# WALDEN PRESERVE 2

## Filing No. 4

# Construction Drawings

**PCD FILE NO. SF-18-034**

**CHANNEL SECTION (E)**  
 N.T.S.

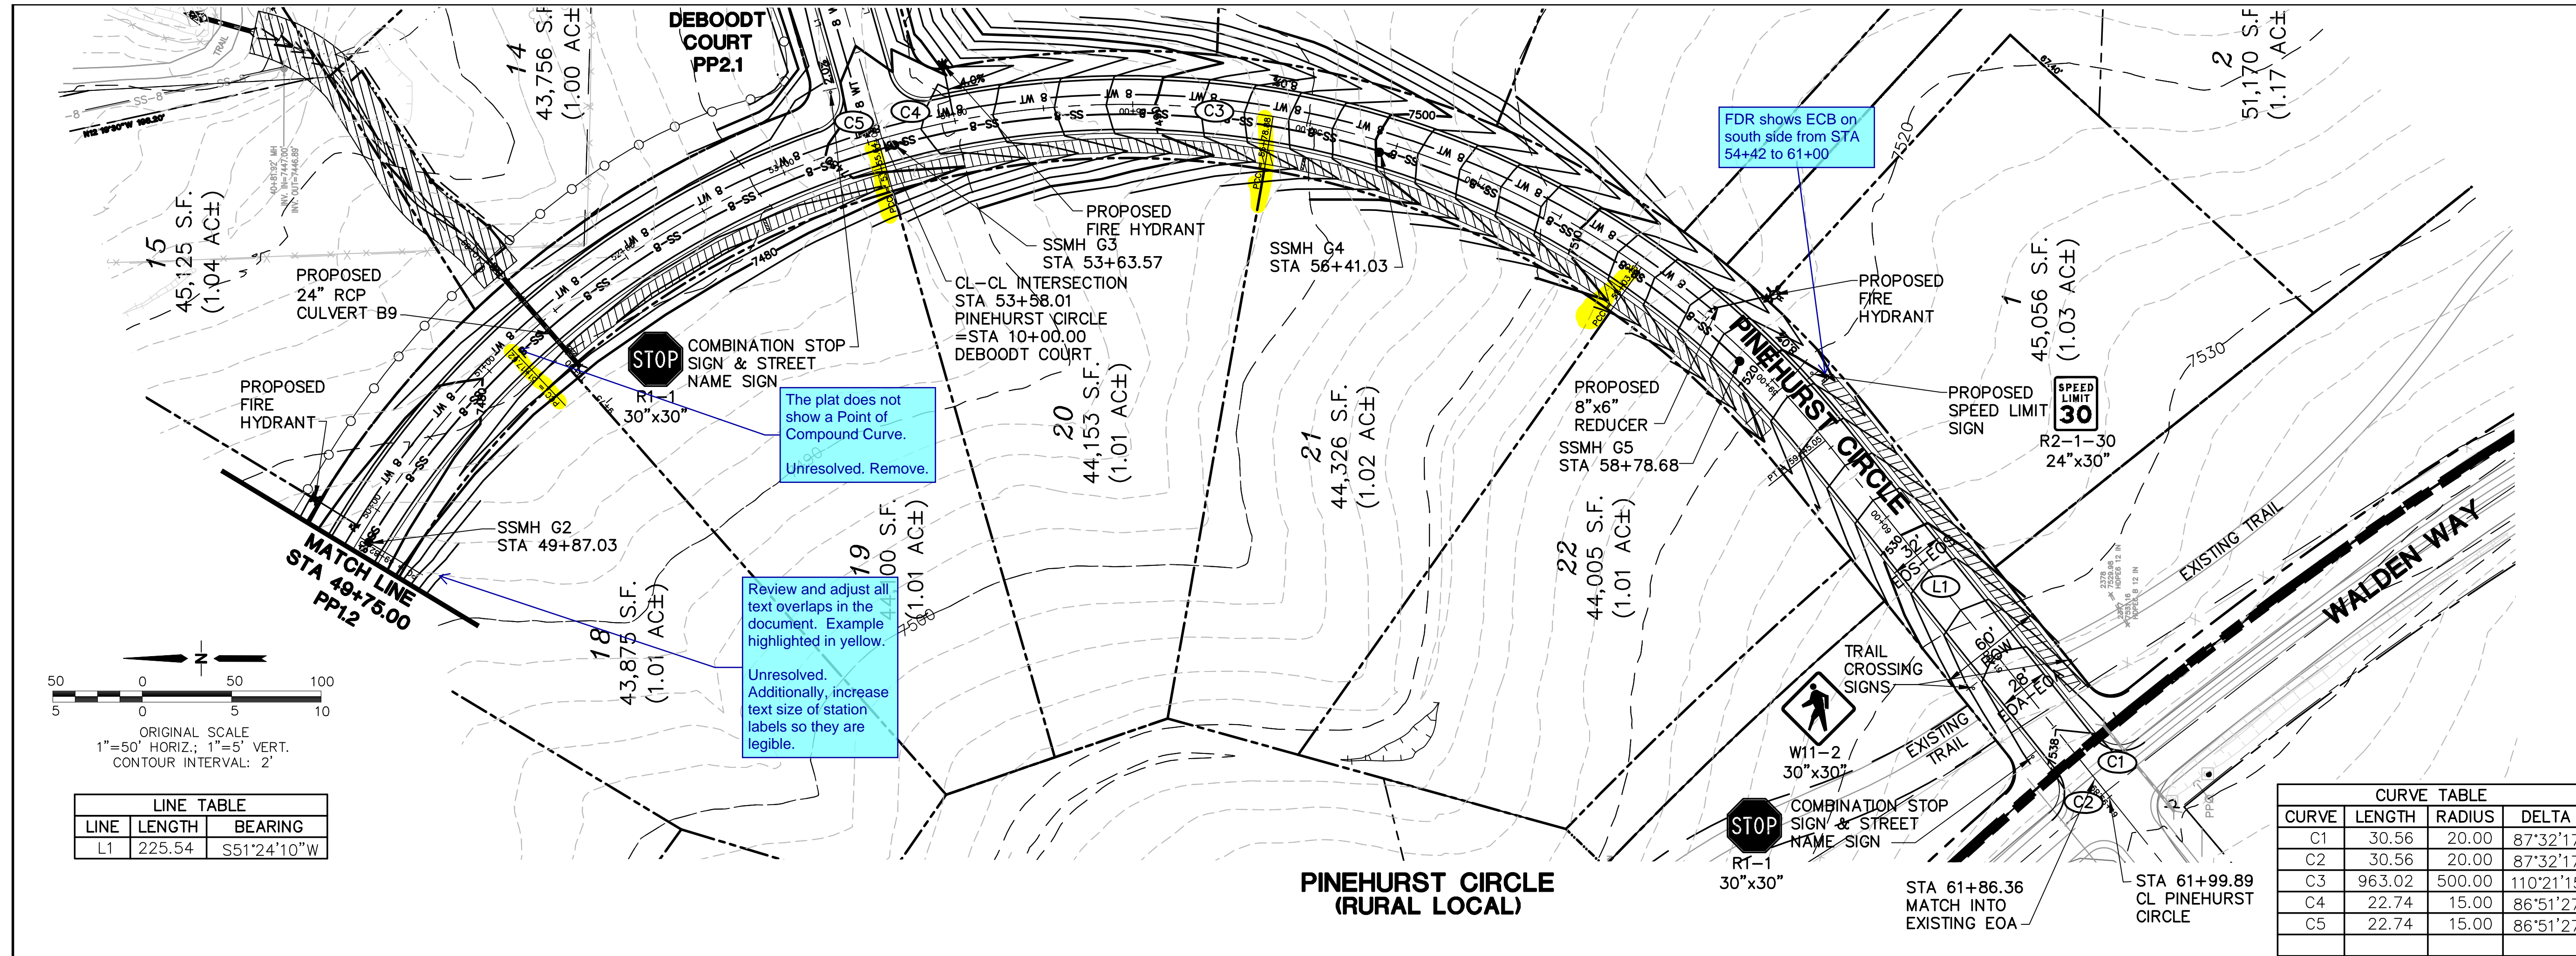
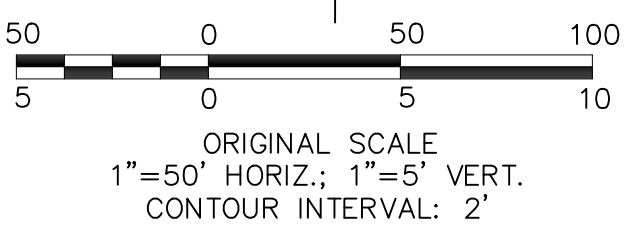
See comments on the Grading and Erosion Control Plans
